Potential For Engine Fires

Number 88-C-23 Date 06/90
 PRODUCT SAFETY CAMPAIGN - 88-C-23
 Subject: LACK OF ADEQUATE SERVICE OR MAINTENANCE

MODELS AFFECTED 1984-88 PONTIAC FIERO MODELS
 WITH 2.5L L4 ENGINES (RPO LR8)

ILLUSTRATION D (Deck Lid)

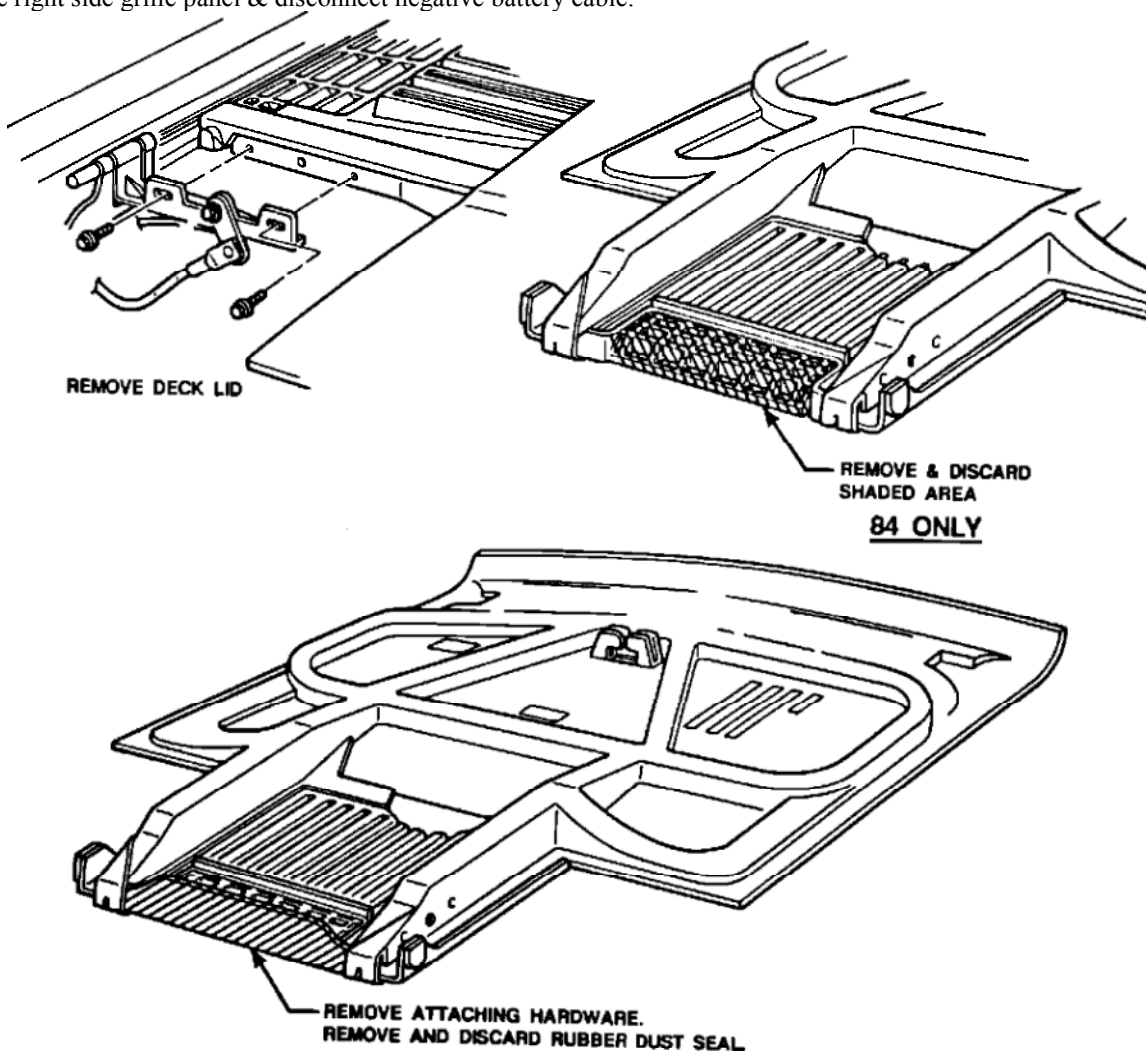
- b. Remove rear engine compartment lid (on 1984 models also remove center grille from engine compartment lid). Remove rubber dust seal and retaining clips (rivets) from leading edge (front) of decklid assembly (and leave off). On 1984 vehicles, remove plastic deflector from underside of decklid grille opening (and leave off); reinstall center grille. (See Illustration D for component identification.)
- c. Remove air cleaner assembly.
- d. Remove dipstick tube.

ILLUSTRATION E (Harness Taping)

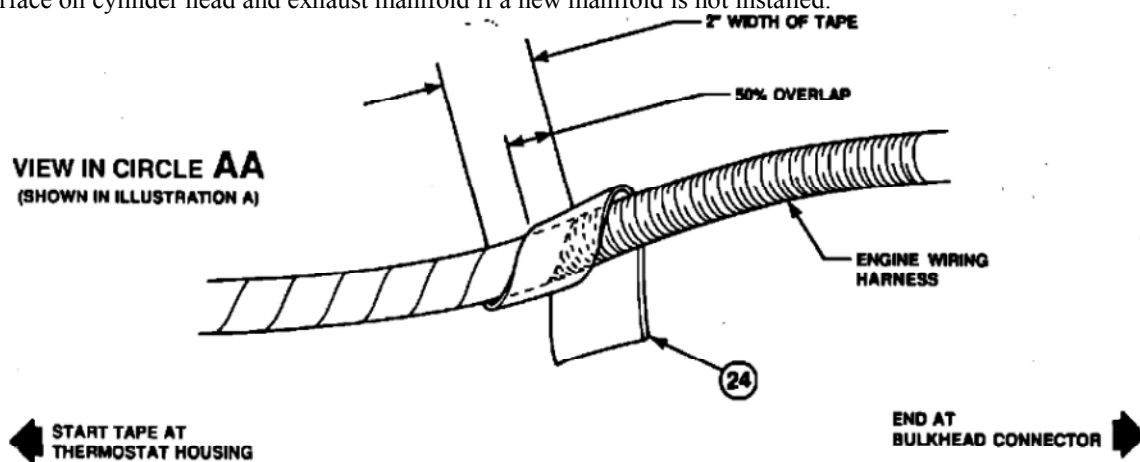
- m. Install protective tape wrap (provided in kit) on engine wiring harness starting at thermostat housing and ending at bulkhead connector on 1984 vehicles (Illustration E).

ILLUSTRATION A - 1984-86 MODELS

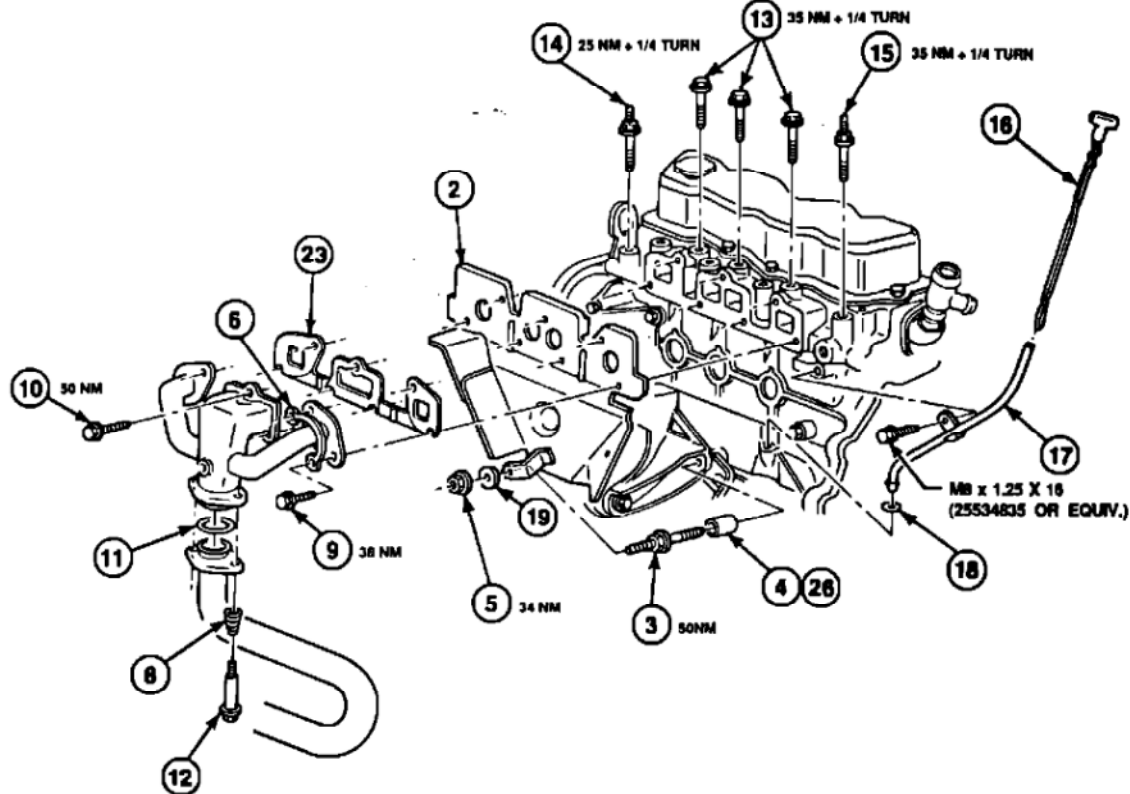
Install new cylinder head bolts (1984-86 vehicles only) provided in kits. New cylinder head bolts should be installed using torque values described in Illustration A & B. HEAD BOLTS SHOULD BE REPLACED ONE AT A TIME. If a broken head bolt is encountered, refer to Dealer Service Bulletin 87-6(GAS)-94 for the proper procedure.

Manifold bolts should be installed using torque values described in Illustration A, B & C. Lock tabs (# 6, 1984-88) should be installed on outboard manifold runner bolts.

Install remaining manifold to converter pipe bolt (# 12) and tighten using torque values described in Illustration A & B.

- w. Lower vehicle.
- x. Remove starter motor heat shield and clamps (may already be removed) from exhaust manifold to convertor exhaust pipe.
- y. Install new heat stove (# 20 & 25, 1984-86 only) as shown in Illustration A with band clamps (# 20) on front pipes.
- z. Install air cleaner assembly. aa. Connect negative battery cable and install right side grille panel.

ILLUSTRATION F - 1984-88 MODELS (Heat Shields)

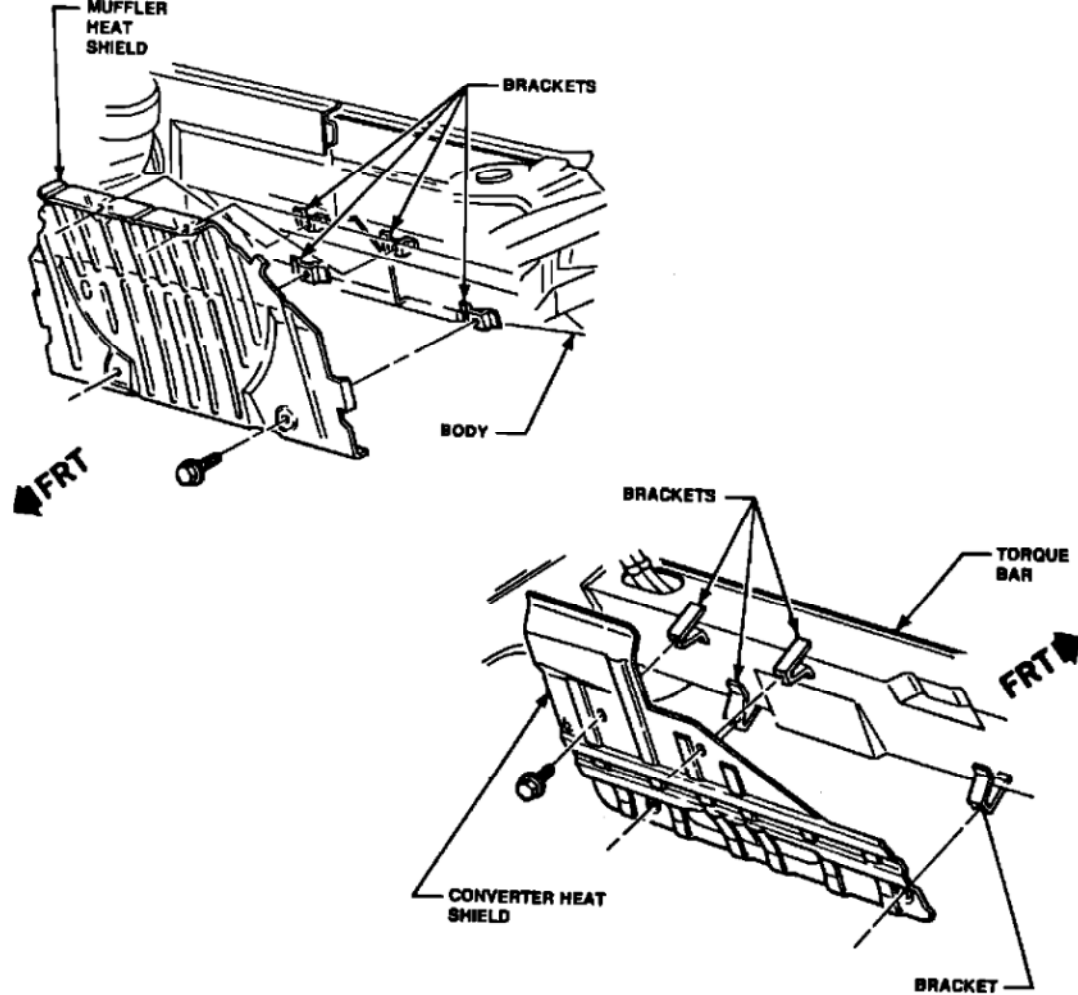
- b. Visually inspect for presence of appropriate heat shields. Repair or replacement will be authorized for starter shield, convertor shield, muffler shield, or bulkhead shields. See Illustrations F and G for correct configurations.
